Parks and Trails Advisory Board
Meeting Minutes - Approved
Monday, March 6, 2023 6:00pm

FPL-20-2023 Preliminary and Final Plat

**Parks and Trails Advisory Board Staff Report
March 6, 2023 Meeting**

**ALDEN WOODS SUBDIVISION
PARKS AND OPEN SPACE REVIEW**

Approximate Site Location:

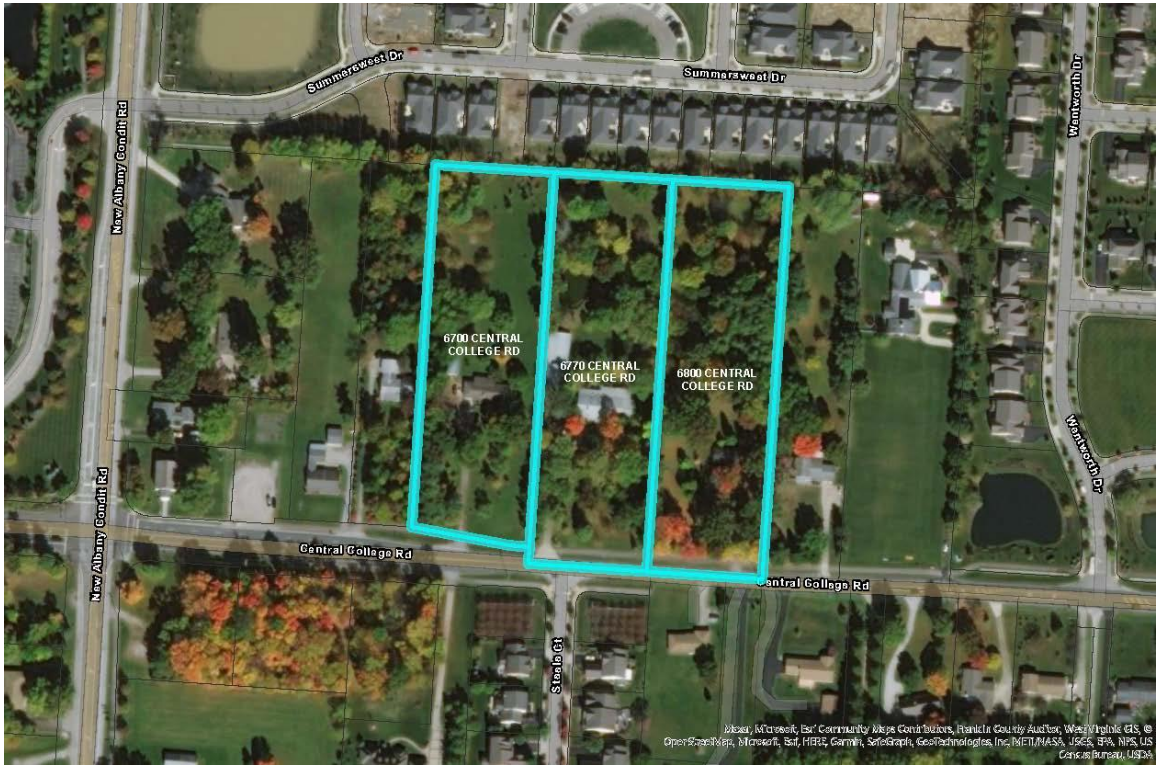
Vice Chair Steelman asked how far is the retention pond was from Central College Rd.

Vice Chair Steelman asked whether there was a plan for fencing since the pond is so close to the road.

Board Member Schaper remarked that the perimeter of the playground did not appear to have a sidewalk.

Board Member Schaper further remarked that a sidewalk on the perimeter would also provide a visual barrier and a safety function for children who might be chasing a ball.

Board Member Stoughton asked about the pond. She stated that she was concerned about kids getting too close to the pond. She asked whether, in other neighborhoods the ponds were separated by the roads or fencing.

Board Member Bhat stated that she would like to make the piers taller or otherwise providing structures for kids up to 12 as a condition of approval.

1. The city engineer comments regarding the final plat must be addressed at the time of engineering permits, subject to staff approval;
2. Shaded areas, seating, picnic tables and trash receptacles shall be incorporated into the design of the playground area for Reserve C, subject to staff approval;
3. The ground material for the playground area shall be subject to staff approval at the time of permitting; and
4. The playground amenities shall be installed and included as part of the overall subdivision infrastructure improvements (e.g. streets, utilities, etc.).

1. The city engineer comments regarding the final plat must be addressed, subject to staff approval;
2. Shaded areas, seating, picnic tables, and trash receptacles shall be incorporated into the design of the playground area for Reserve C, subject to staff approval;
3. The ground material for the playground area shall be subject to staff approval at the time of permitting;
4. A dog waste station shall be provided, subject to staff approval; and
5. Play equipment for children ages 6-12 years of age shall be incorporated into the design of the playground, subject to staff approval.
